DEQ Coal Combustion Residuals Surface Impoundment Closure Determination

Mayo Steam Station

April 1, 2019

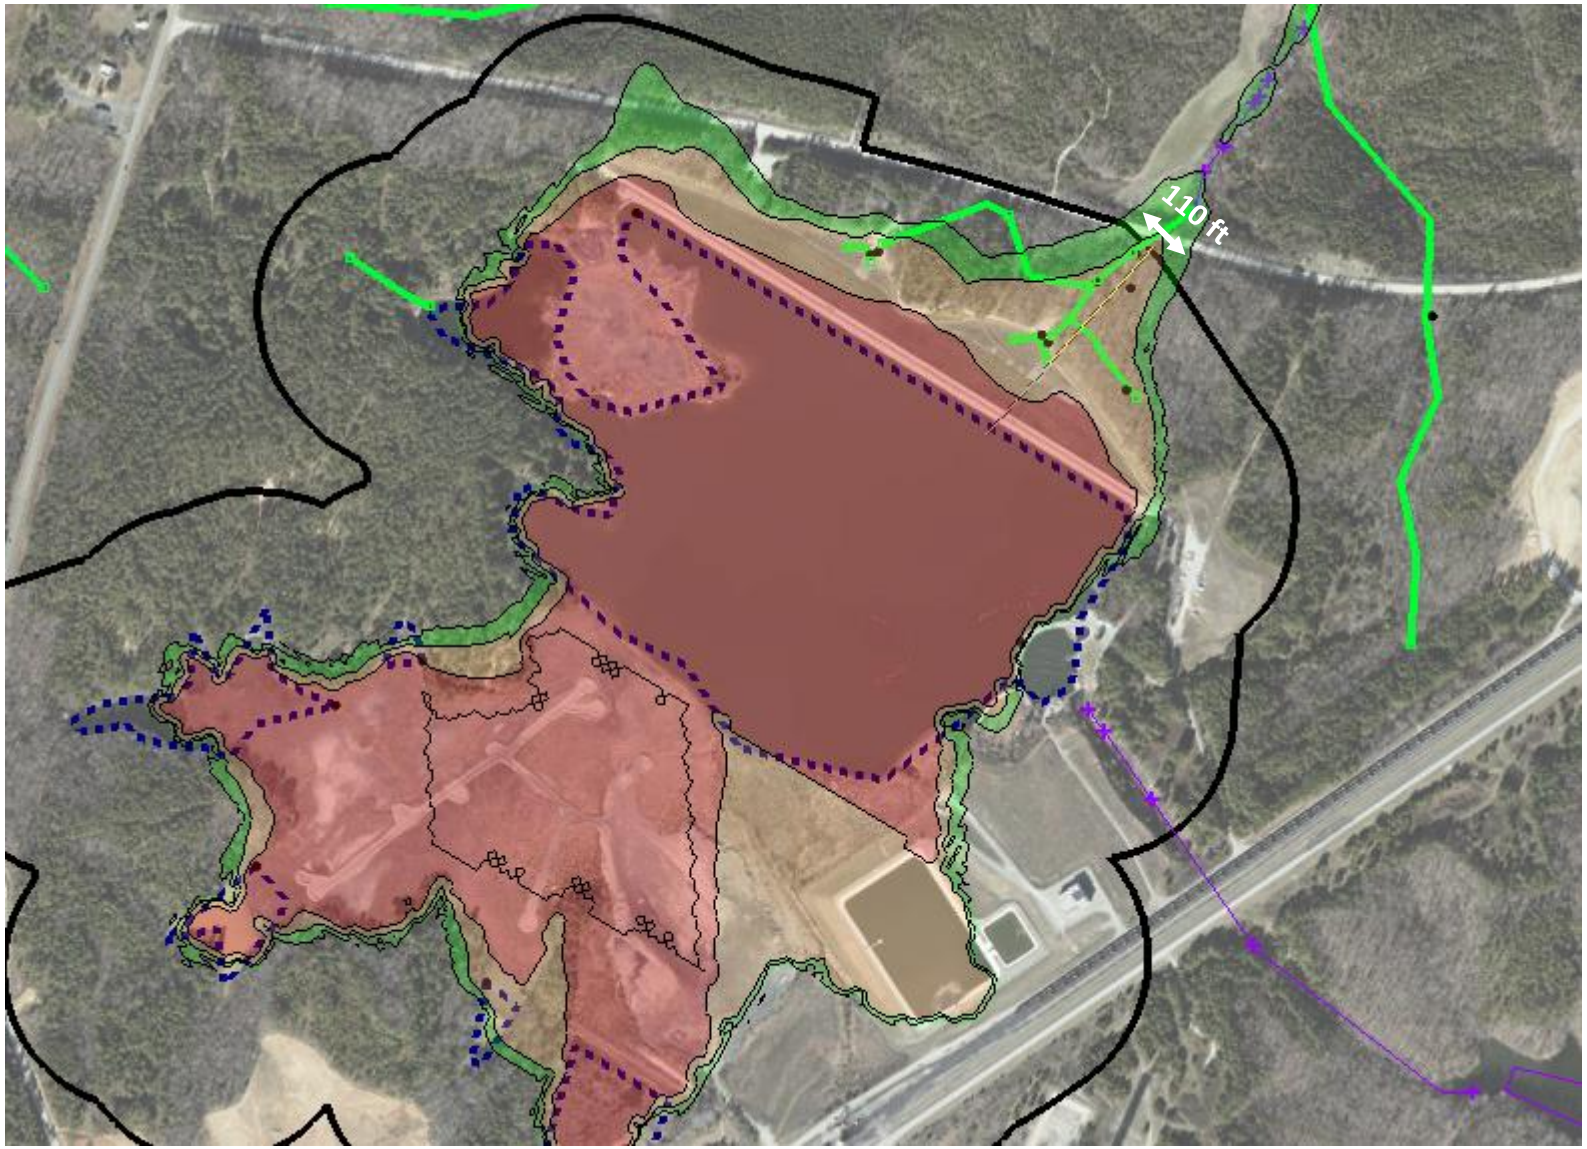
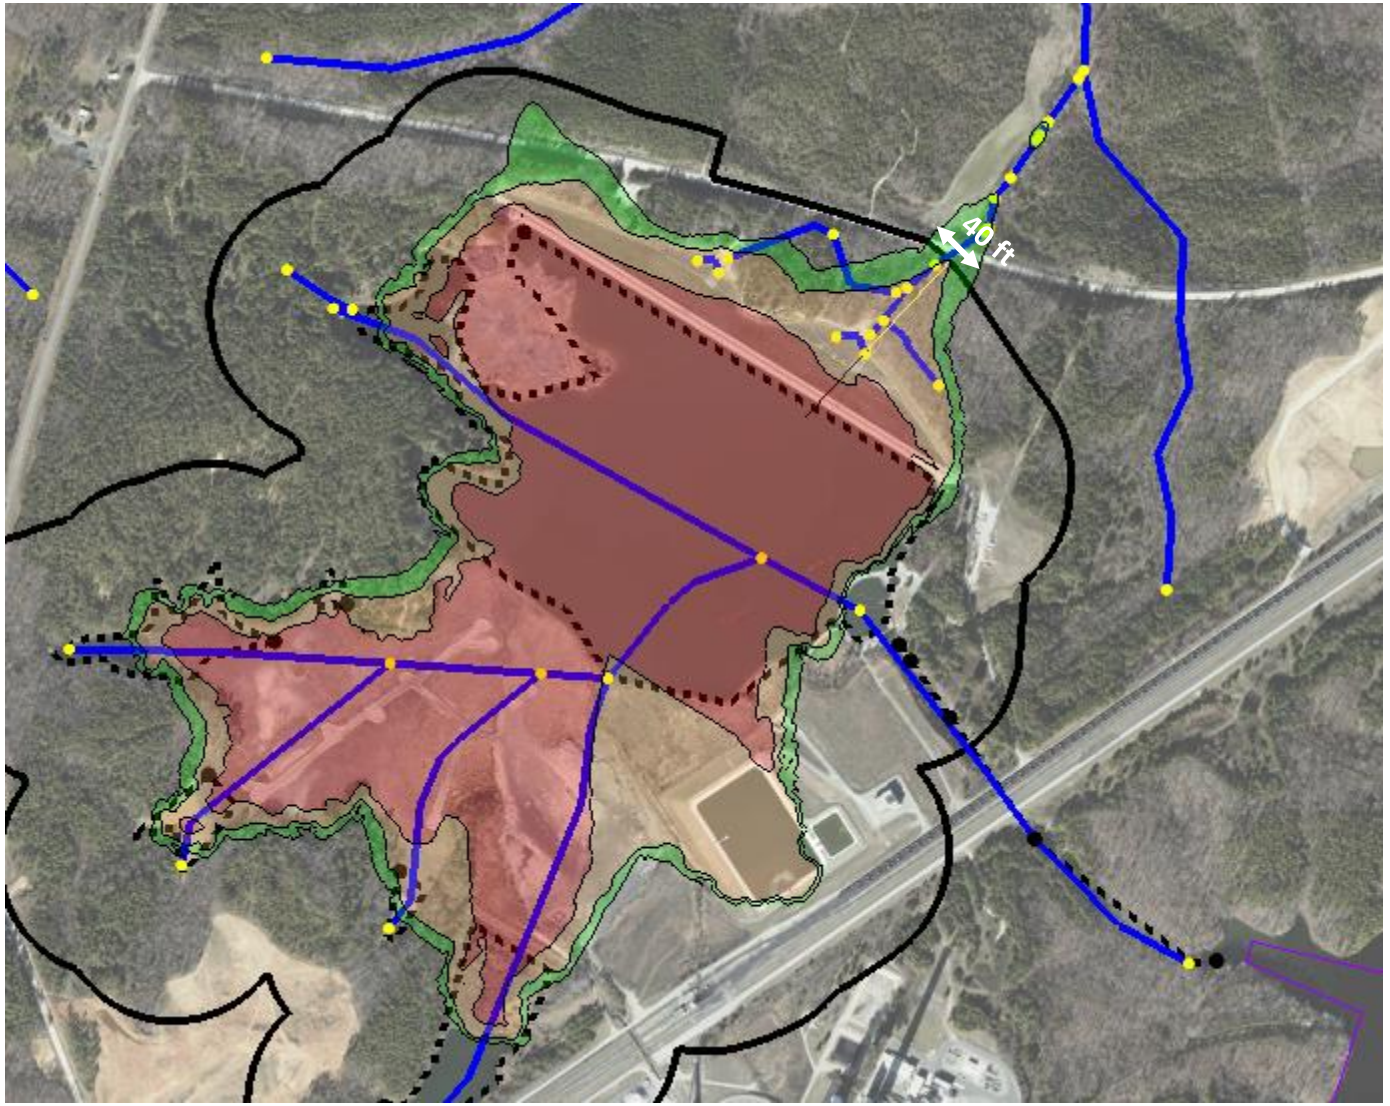
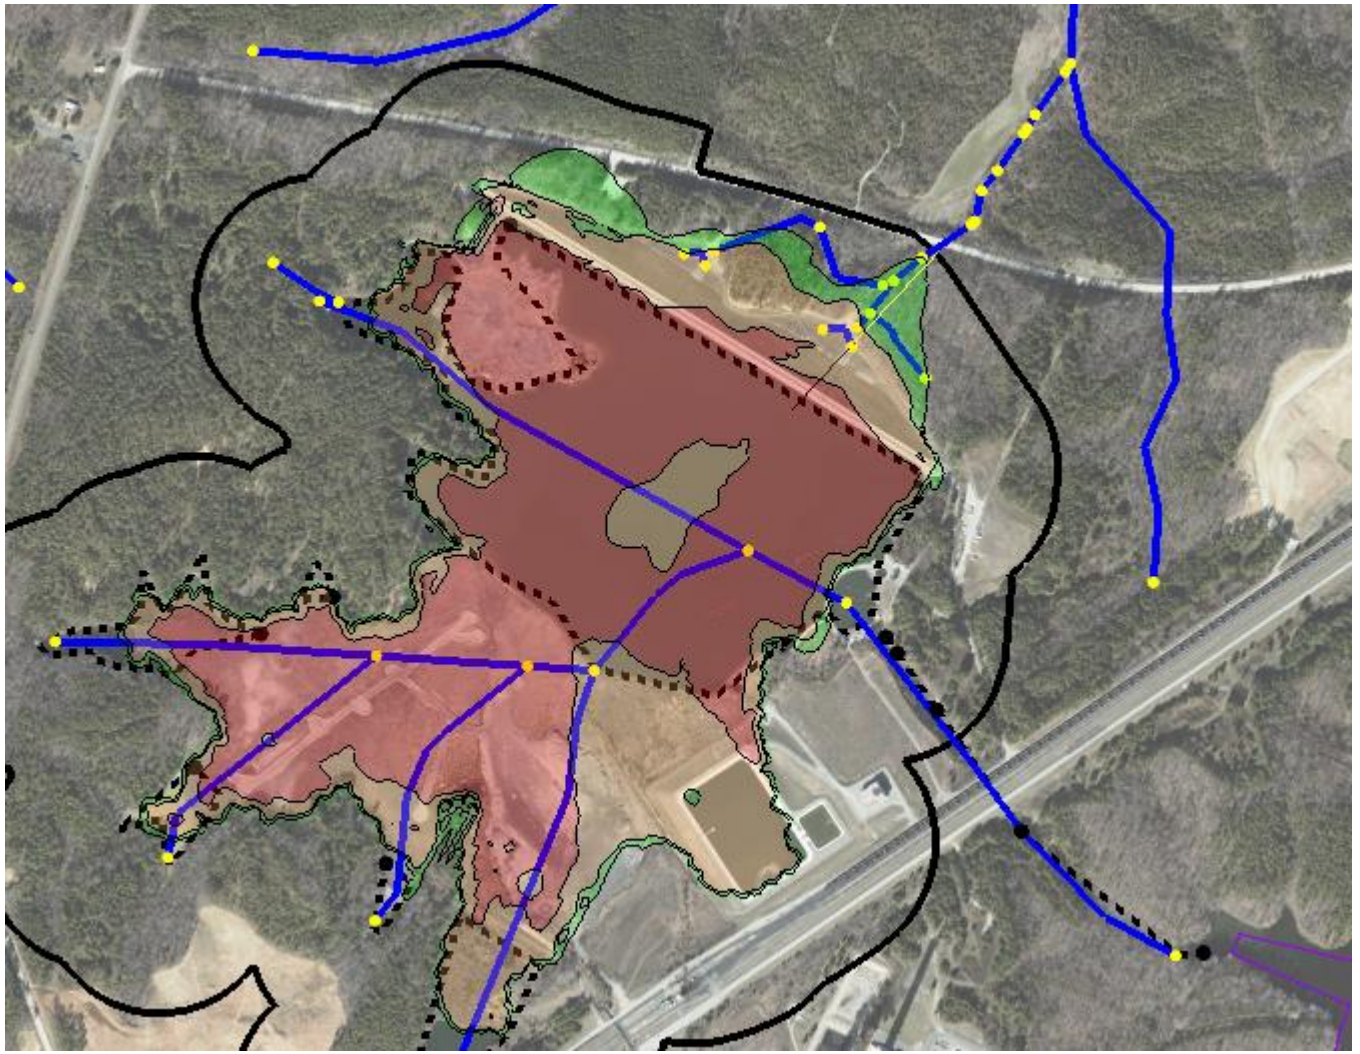
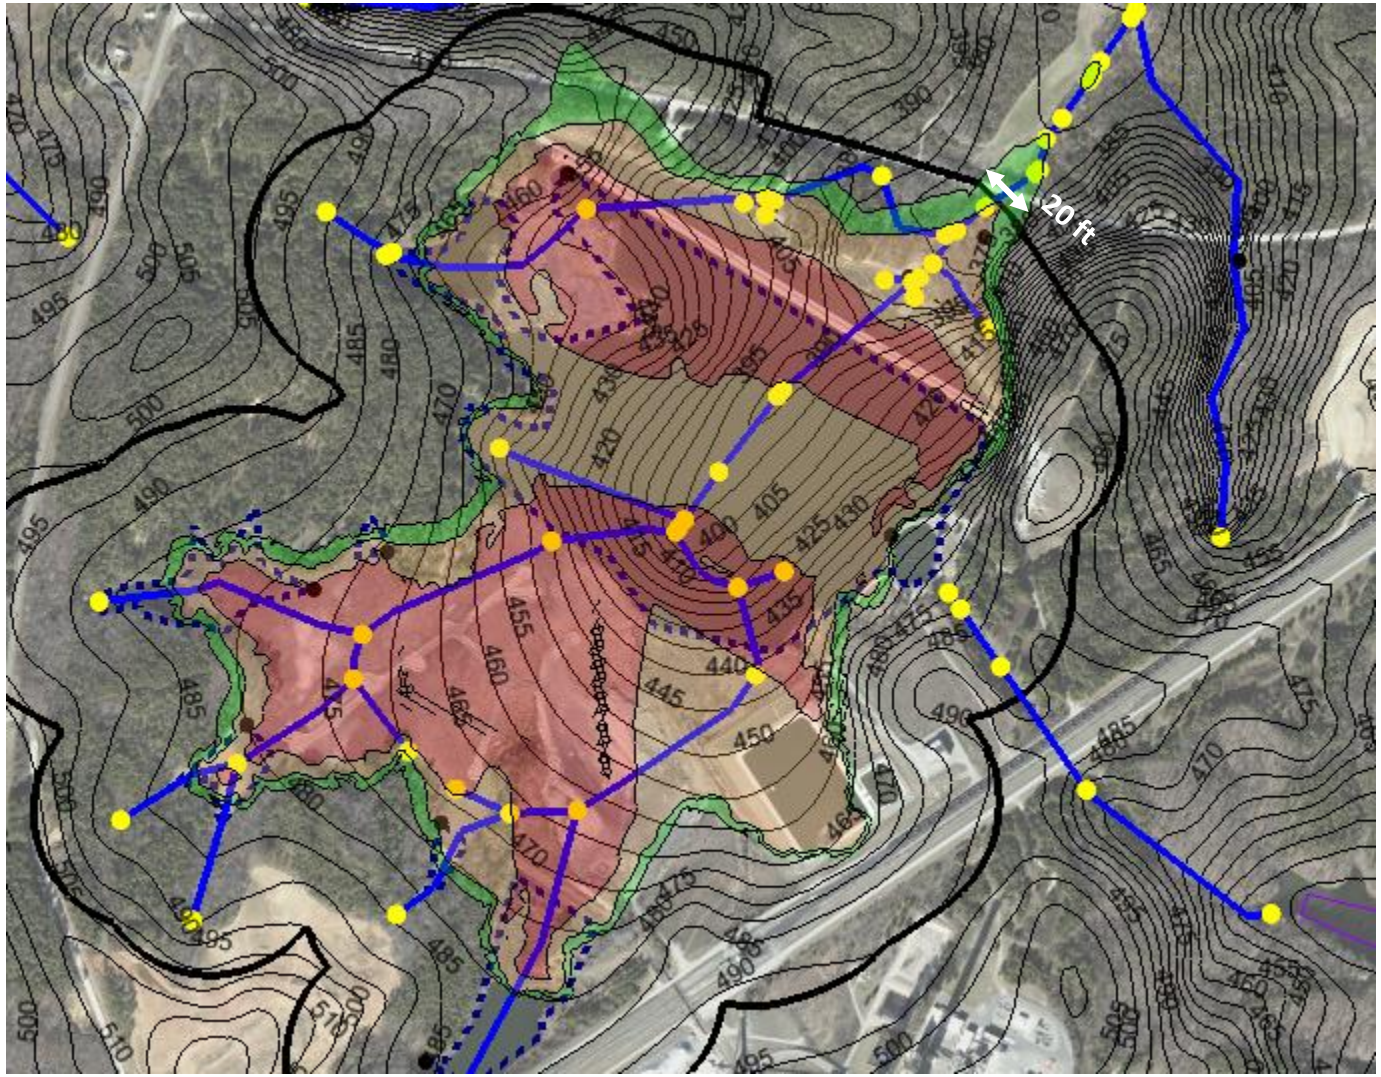
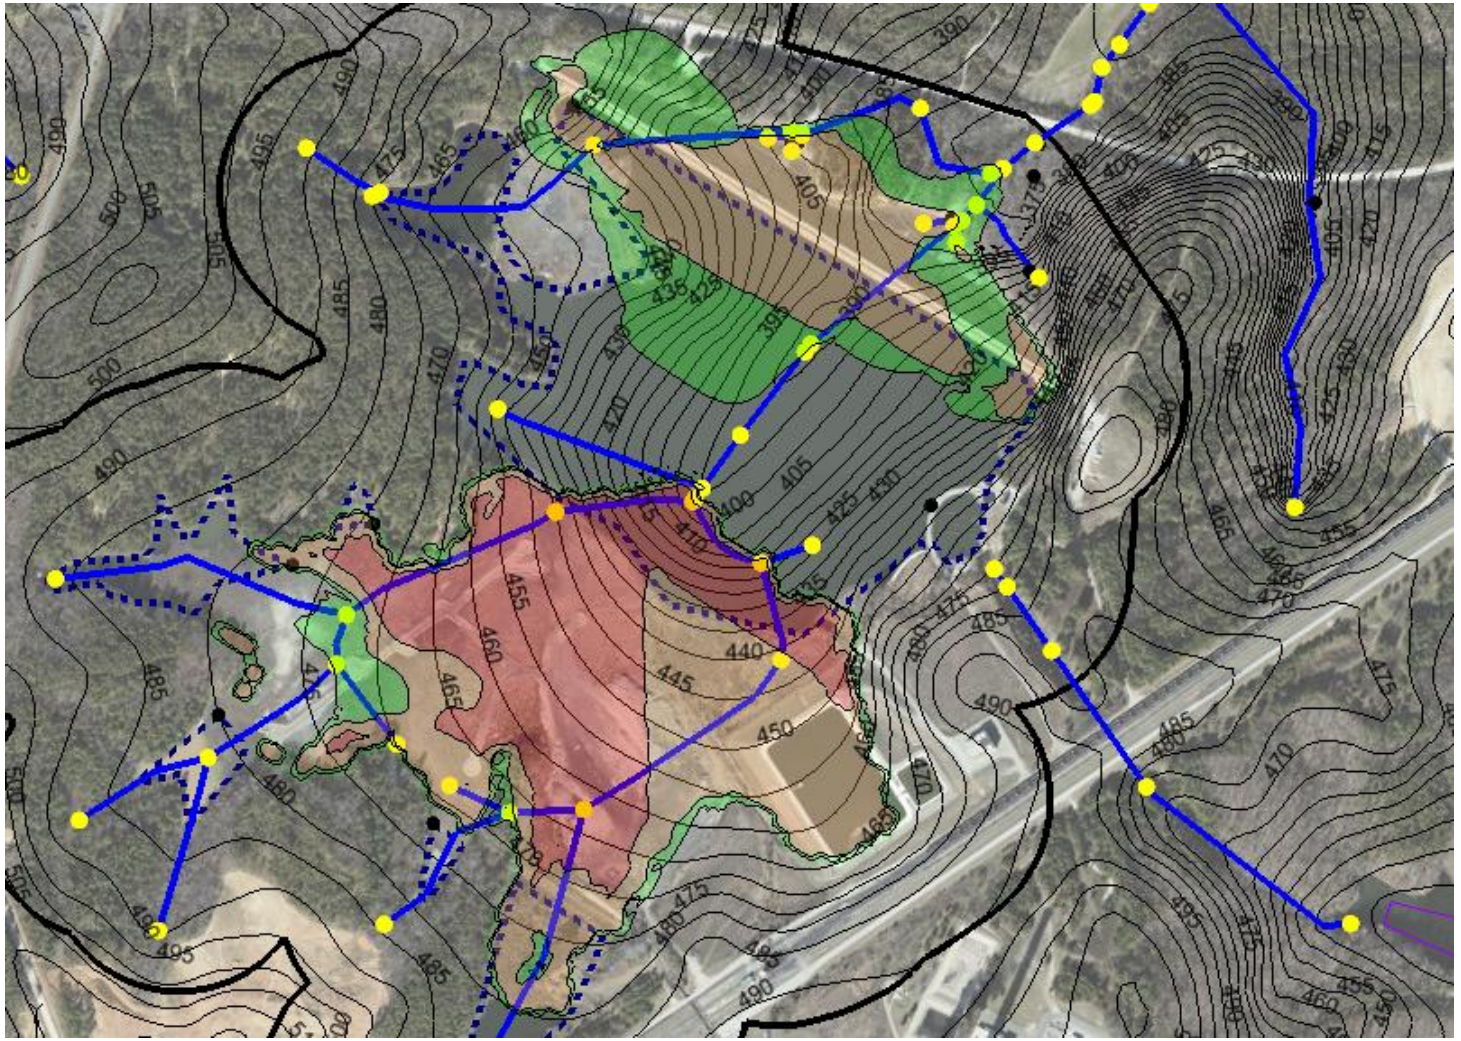
exceedances of the 2L groundwater quality standards (15A NCAC 02L) at the compliance boundary upon the plan's full implementation. Cross section A-A' was evaluated and can be seen in the figures below. This cross section represents where the boron concentration above the 2L standard of 700 µg/L has crossed the compliance boundary based on groundwater monitoring and modeling.
